# Response to Submissions Report

## Eden Breakwater Wharf Extension

Department  
of Industry  
Lands

### **Project No: 301311-13734-EN-REP-0009 – Response to Submissions Report: Eden Breakwater Wharf Extension**

**Figure 4-2 Option 2, hindcast wind scenario: proximity of benthic habitats and proposed monitoring locations to the dredge plume modelling TSS dispersal in Snug Cove**

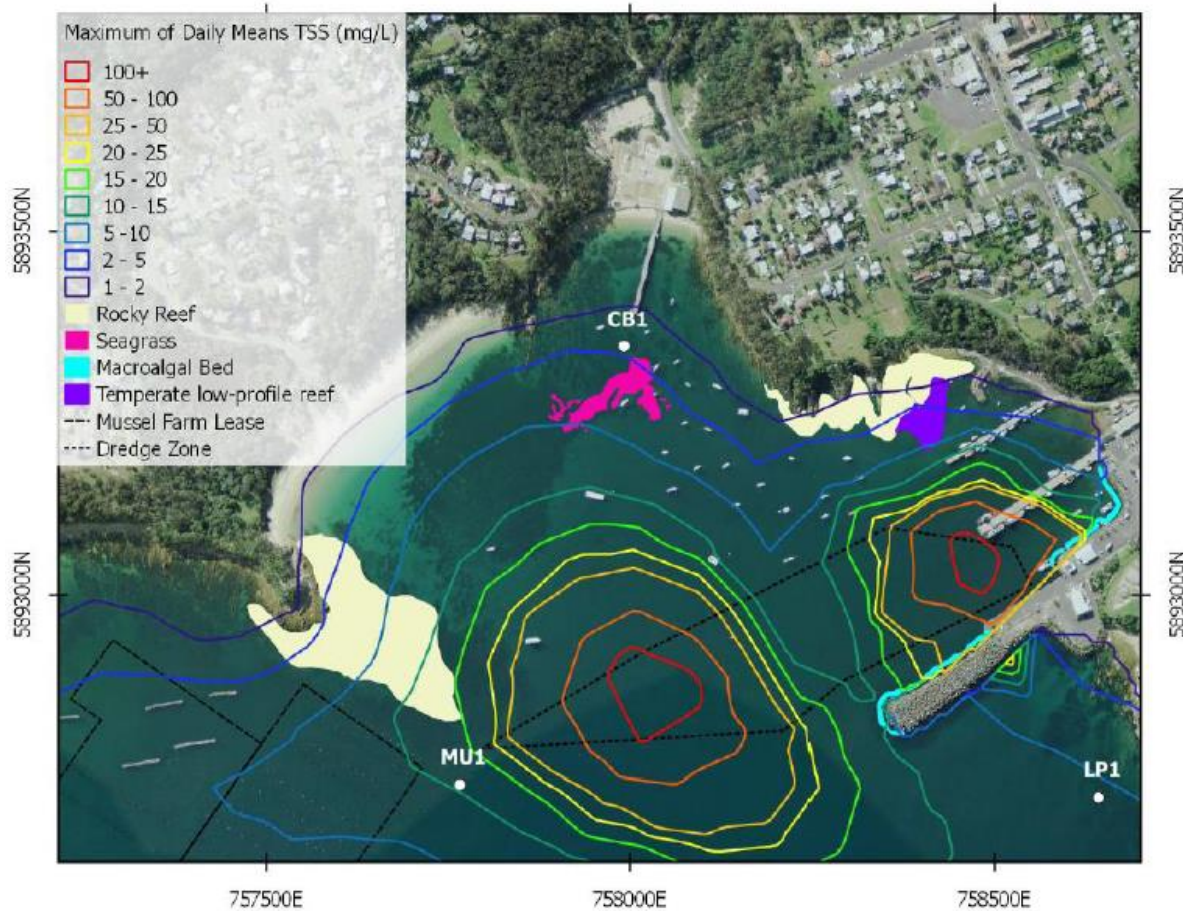
- *Water Quality Assessment for Dredging Option 2. The submitted Water Quality Assessment only addresses Option 1 and Option 3 (as worst case scenario).*
- *Confirmation that the sub-heading on p76 "Option 3 BHD + TSHD (Single Handle Method)" should read "Option 3 BHD + TSD (Partial Double Handle Method)".*
- *Confirmation that the Dredge Plume Modelling includes the potential use of a 'Drumcutter' for rock extraction.*
- *In regard to trigger value response levels:*
  - a) An adjustment of the trigger response levels to reflect the expected performance of the dredging operation within a finalised baseline water quality monitoring program (having regard for the results of current field data collection program and detailed dredge plume assessment);*

In summary, Dredge Option 2 is predicted to produce similar total suspended solids (TSS) increases at the proposed seagrass and mussel farm monitoring locations as Dredge Option 3.

Modelling results for the hindcast wind scenario predicted that maximum daily mean TSS increases are 1-2mg/L above ambient at the proposed CB1 monitoring site in Cattle Bay, 10-15mg/L above ambient at the MU1 monitoring location, and 5-10mg/L above ambient at the LP1 monitoring location shown in Figure 4-2 below.

Seagrass in Cattle Bay would be expected to be exposed to low levels of TSS from the dredging operation under Option 2 and moderate levels of TSS under Option 3, as predicted from the dredge plume models. The sediment plume is not expected to extend into Cattle Bay under the Option 1 dredge scenario. Regardless of the dredge option selected, the dredge plume associated with the dredging program is not expected to result in permanent damage to the seagrass in Cattle Bay, as rhizomic seagrass are capable of drawing upon energy reserves in their root mass in order to offset periods of low light or enable growth from burial.
